Service Kit: SK-427EC-800-1

Title: Replacement of Model 427 Air Conditioner Evaporator & Condenser Blower Motors to eliminate HF radio RF interference.

Date: June 23, 2002

Figure 1-1 Blower Wheel Clearance Criteria

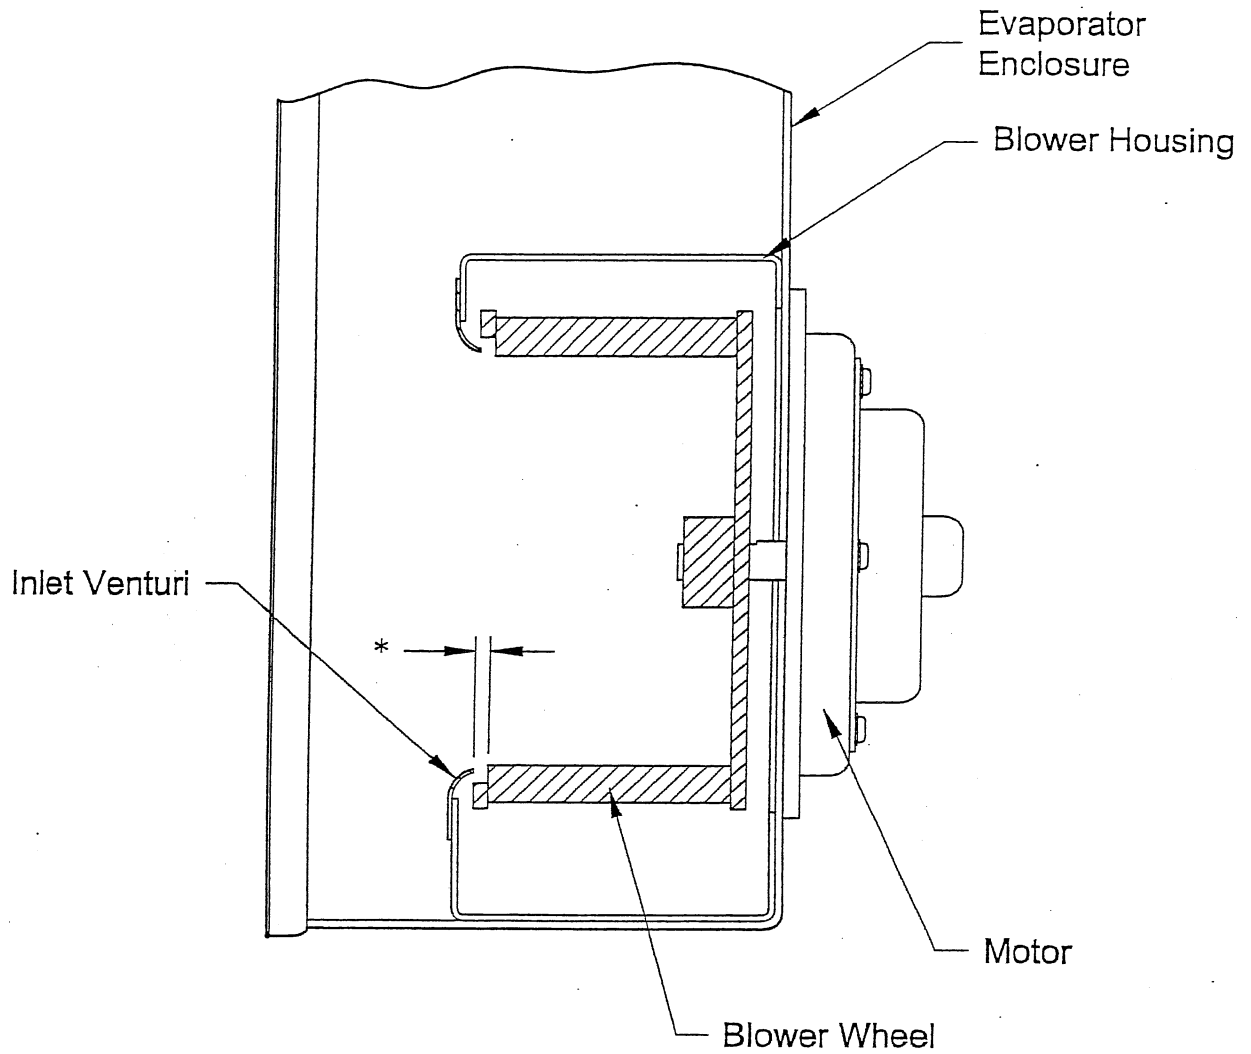
Care should be taken to locate the blower wheel as shown in Figure 1-1. The blower wheel must not rub the inlet venture ring.

* Blower Wheel fins should be located approximately .10 from edge of Inlet Venturi. BLOWER WHEEL MUST NOT RUB DURING OPERATION.

Schematic 1

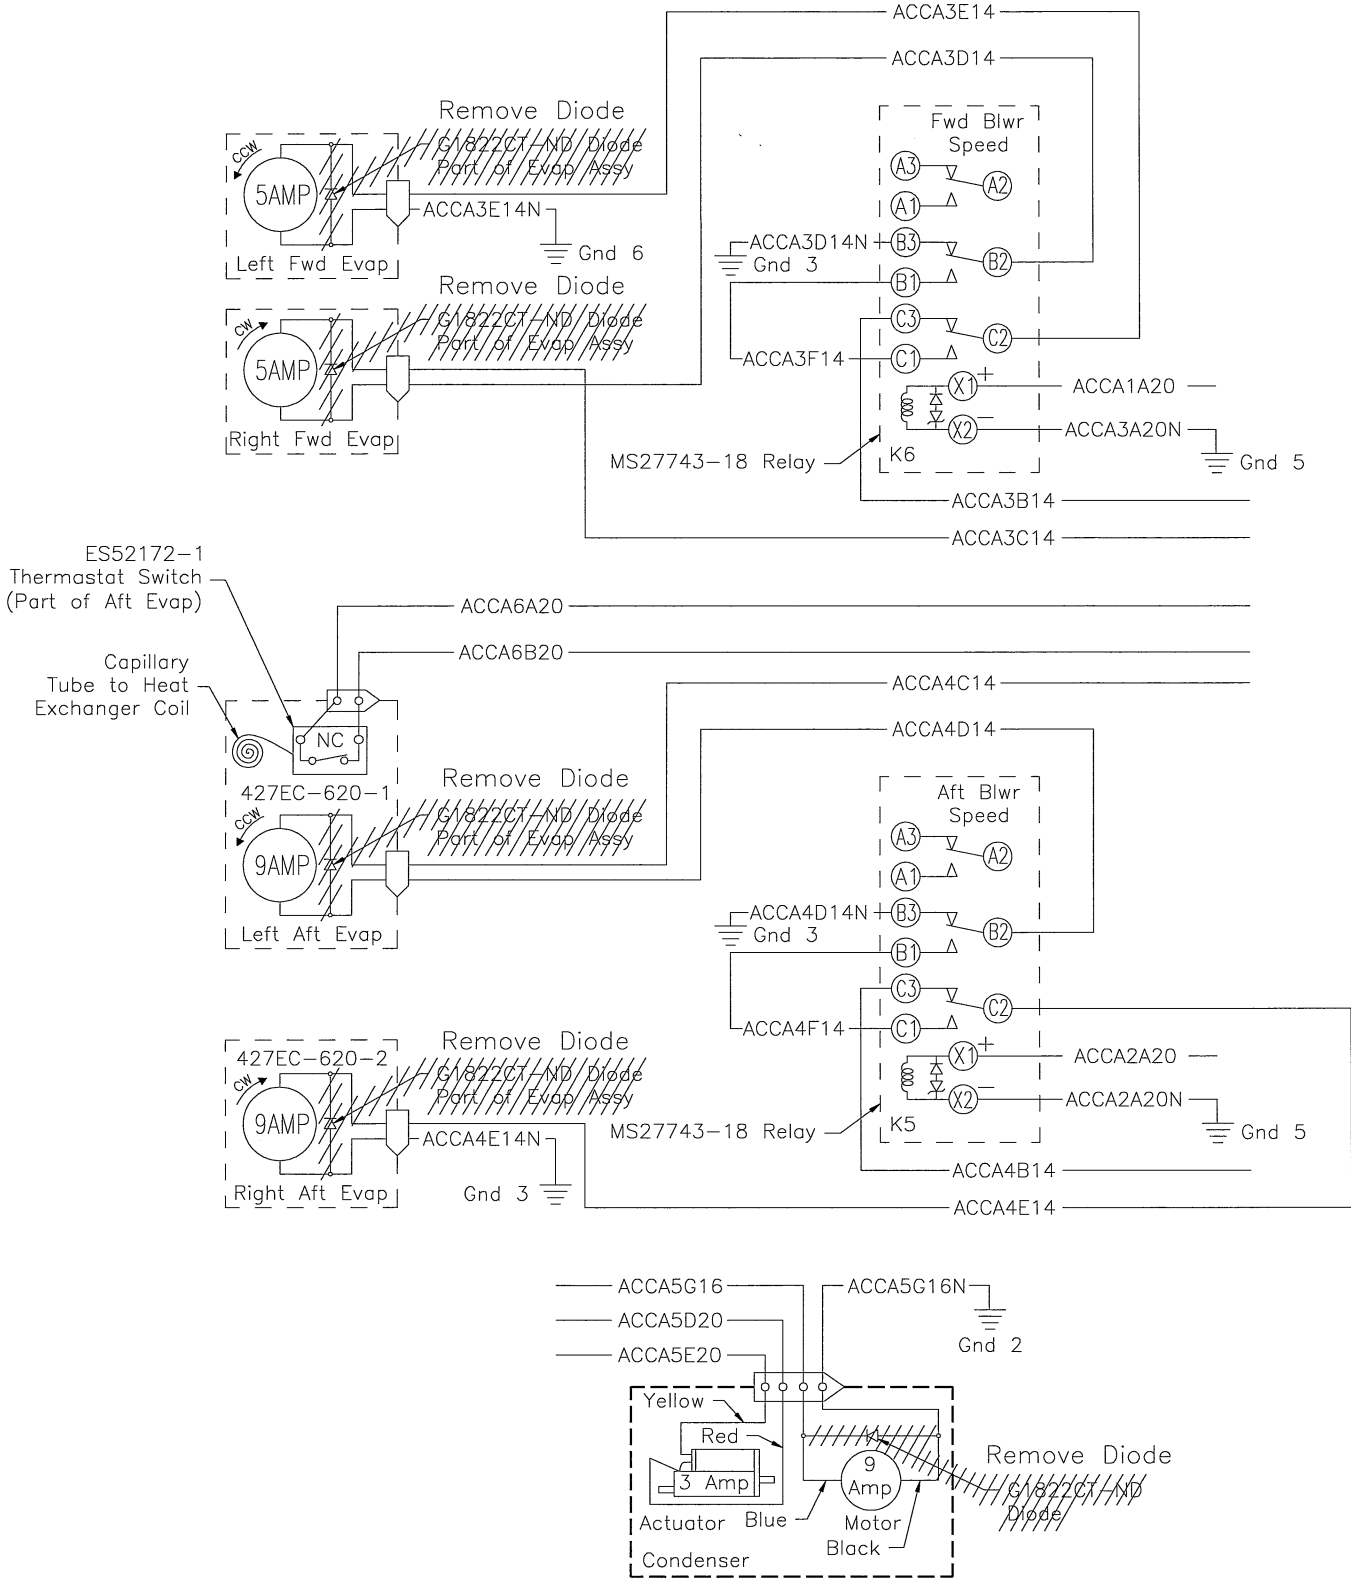
If "Free-Wheeling" diode was previously installed, then remove it during installation of the RFI/EMI filtered evaporator blower motors and brushless condenser blower motor
(See Schematic 1 on Page 5)

(Remove "Free-Wheeling" Diode from the shown locations during installation of the EMI/RFI filtered evaporator blower motors and brushless condenser blower motor)

No external "Free-Wheeling" diode is required when RFI/EMI filtered evaporator blower motors and brushless condenser blower motor are installed.
